DOCUMENT 00 90 00
ADDENDUM

ADDENDUM NO. [2] **Date: June 15, 2020**

RE: WESTERN TECHNICAL COLLEGE
CLEARY COURTYARD BRICK PAVER REPLACEMENT
400 6th STREET NORTH
LA CROSSE, WISCONSIN 54601
HSR PROJECT NO. 20007

WESTERN TECHNICAL COLLEGE
CLEARLY PLAZA
400 6TH STREET
LA CROSSE, WI 54601
DETAILS

UNIT PAVERS @
PAVER EDGING 6
C102

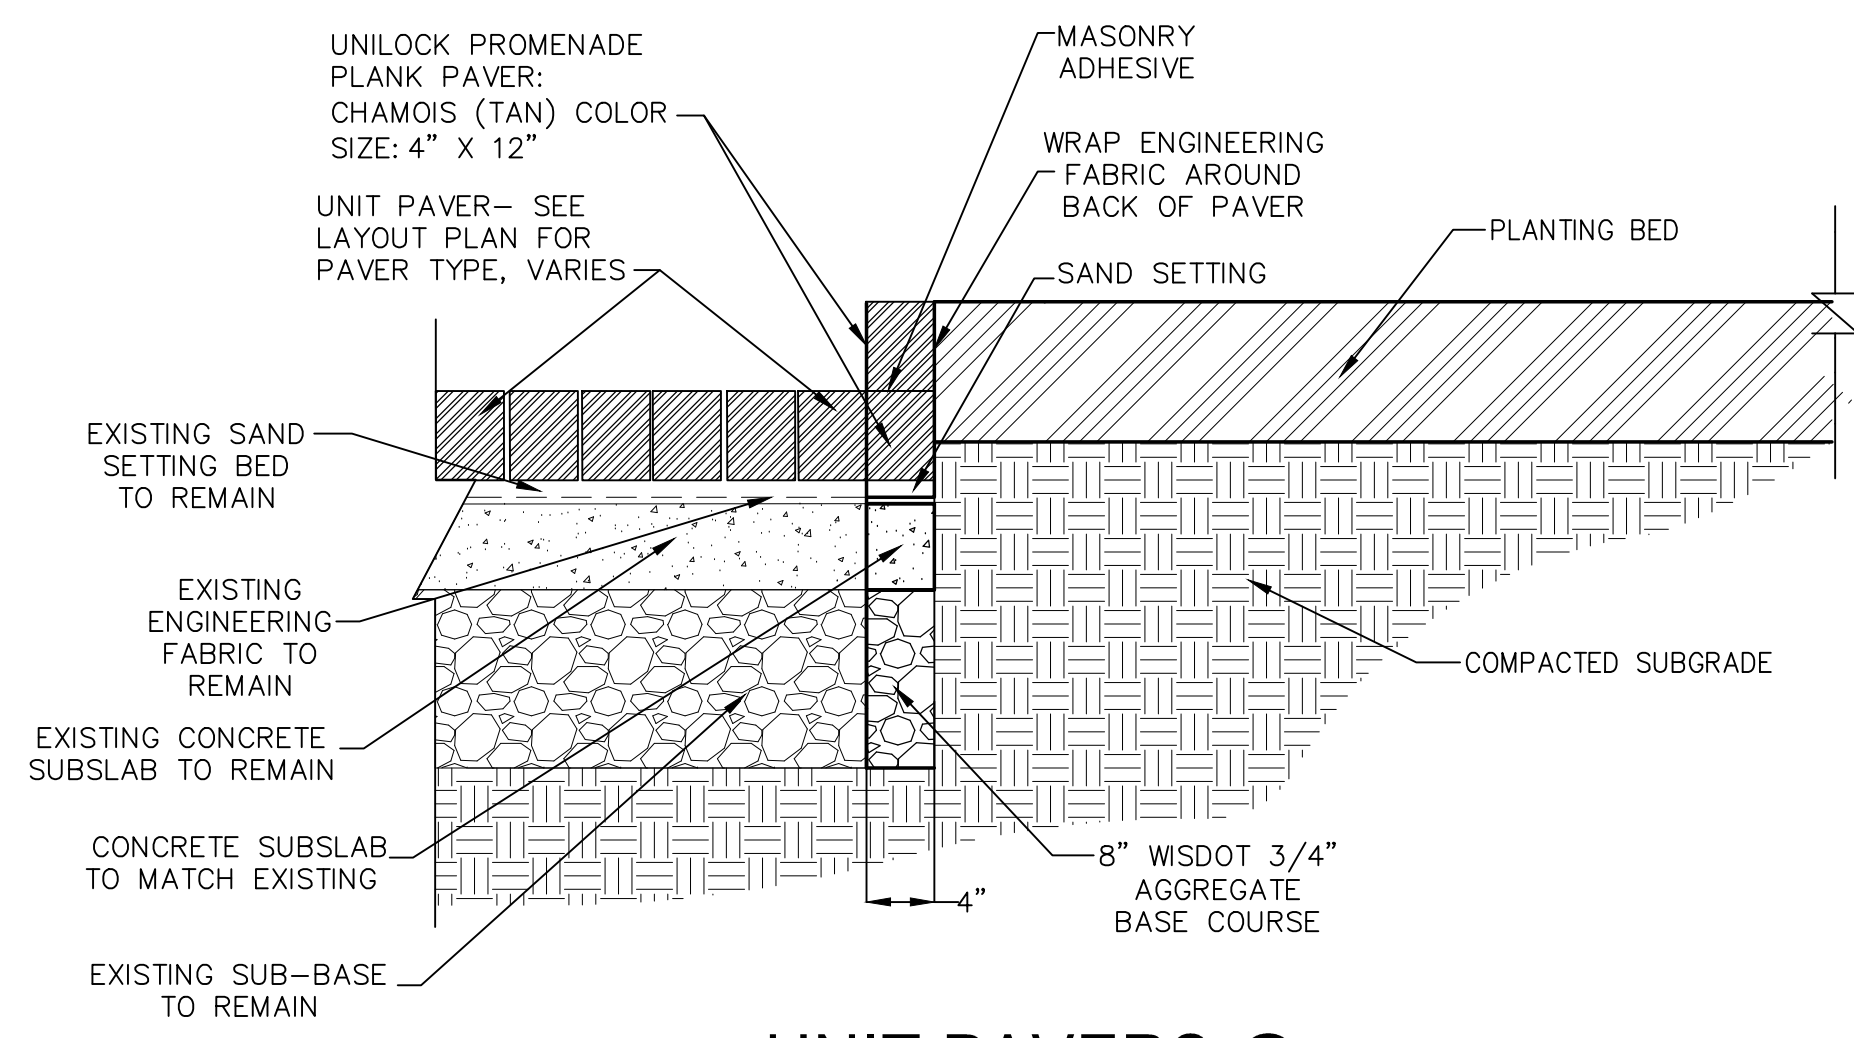
Sieve Size	Percent Passing
3/8 inch (9.5 mm)	100
No. 4 (4.75 mm)	95 to 100
No. 8 (2.36 mm)	80 to 100
No. 16 (1.18 mm)	50 to 85
No. 30 (0.600 mm)	25 to 60
No. 50 (0.300 mm)	10 to 30
No. 100 (0.150 mm)	2 to 10
No 200 (0.075 mm)	0 to 1
 - 7) Engineering Fabric: Acceptable knit fabrics: WS DOT 645.2.4 Geotextile Fabric, Type DF (Drainage Filtration).
6. Sheet C102 DETAILS 30 x 42 attached hereto.
- a. Revisions clouded on Drawing.
